To: Jordan & Skala Engineers, Inc. RFI #: 66  
 14240 Midway Road, Suite 350 Date: 2/24/2012  
 Dallas, TX 75244 Job: EB-02 Keller Springs Lofts  
 Ph: 469/985-1616 Fax: 469/985-1615 Phone: 877-777-5115

Subject: HVAC requirements for elevator shaft

CC:  
 Subject: First Floor Grills Near Elevator #2

Subject: Corridor duct issues

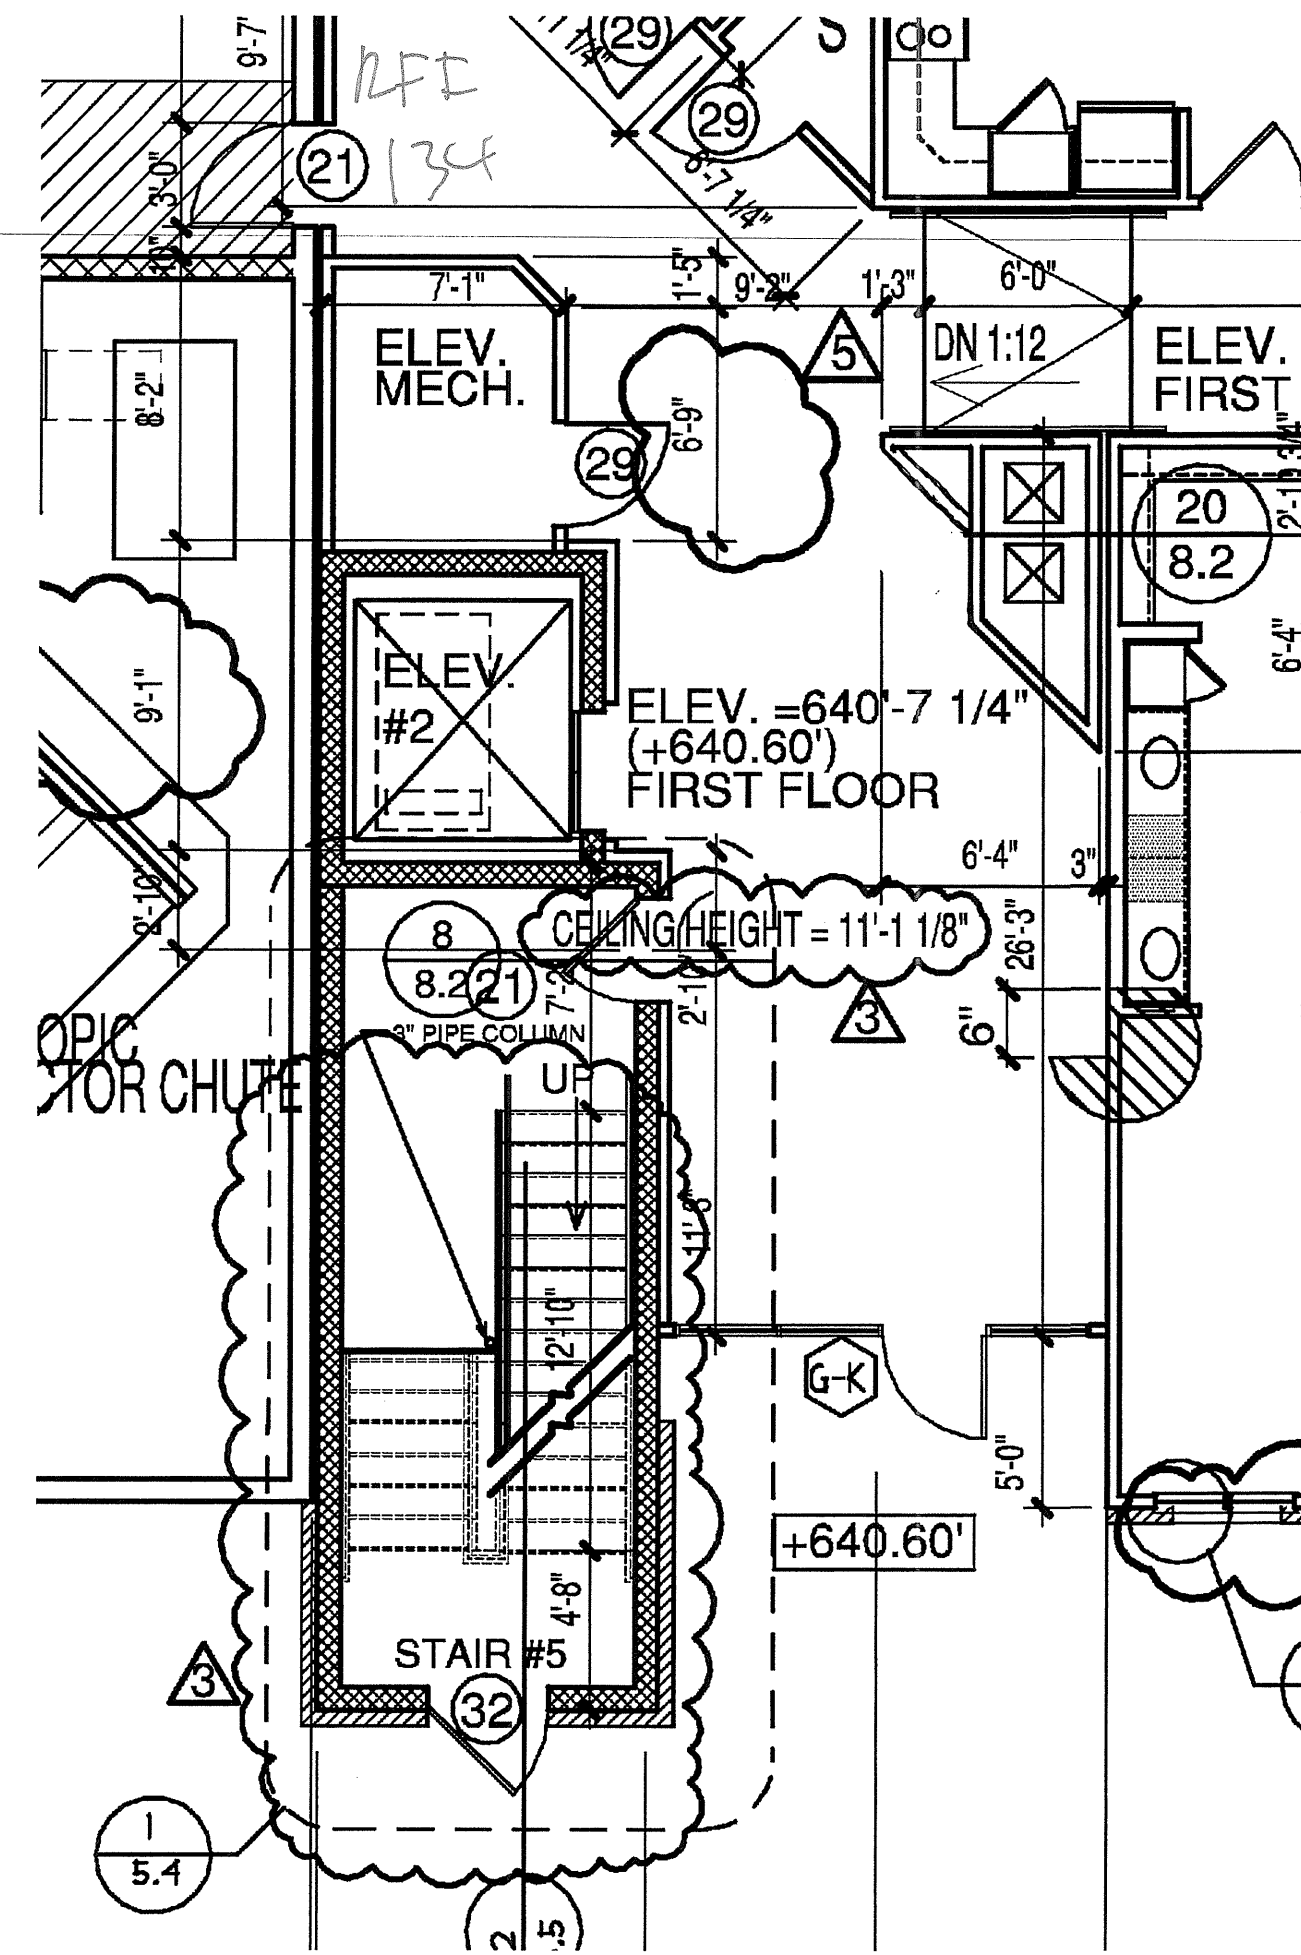
**Request:** Date Required: 6/7/2012  
 Due to the ramp at the mechanical shaft (near elevator #2), there is an added wall on the first floor that is not shown on the other floors. This additional wall will cause issues with the grill located in that area. Detail 7M4.2 shows the walls as they will be on floors 2, 3 and 4. Can the additional wall be modified to give the HVAC sub room for his grill? Please see attached sketch.  
**Requested by:** David Miller  
 Embrey Builders LLC

**Response:** This sketch looks to be what was proposed on RFI-128. GC to verify they are the same solution. I take no exception to this solution.  
 Ryan Faulds  
 BGO architects  
 June 28, 2012  
 Answered by: \_\_\_\_\_  
 Company: \_\_\_\_\_ Date: \_\_\_\_\_
